Electronic Piano Notes

E.P. NOTE No. 14

DECEMBER 10, 1962

CIRCUIT MODIFICATION TO PROVIDE PROTECTION FOR TRANSISTOR "TR-1"

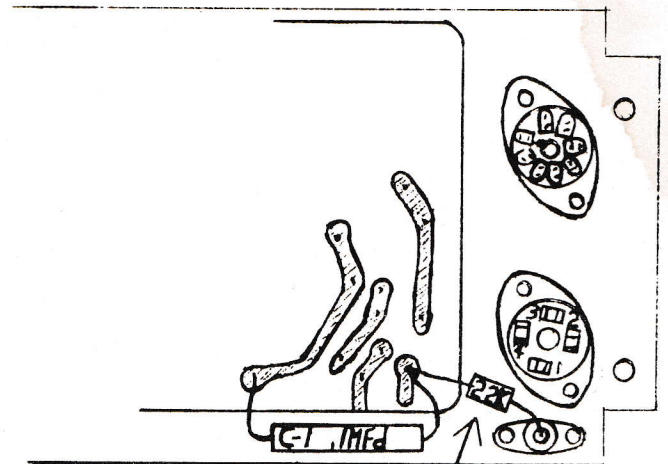
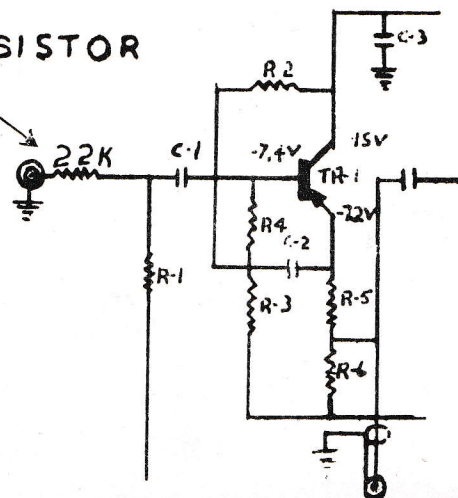
OCCASIONALLY, WHEN TUNING A REED OR SERVICING A REED BAR, AN ACCIDENTAL SHORT CIRCUIT, I.E., LEAD FILINGS, CAN OCCUR WHICH CAUSES A SPIKE PULSE TO SHOCK TRANSISTOR TR-1, RESULTING IN THE POSSIBLE FAILURE OF THE TRANSISTOR.

A 22K RESISTOR IS NOW BEING INCORPORATED BETWEEN THE INPUT PLUG AND C-1. WHENEVER SERVICING THE AMPLIFIER, WE SUGGEST YOU CHECK FOR THIS REVISION, AS ILLUSTRATED BELOW:

ADD THIS RESISTOR

ADD THIS RESISTOR
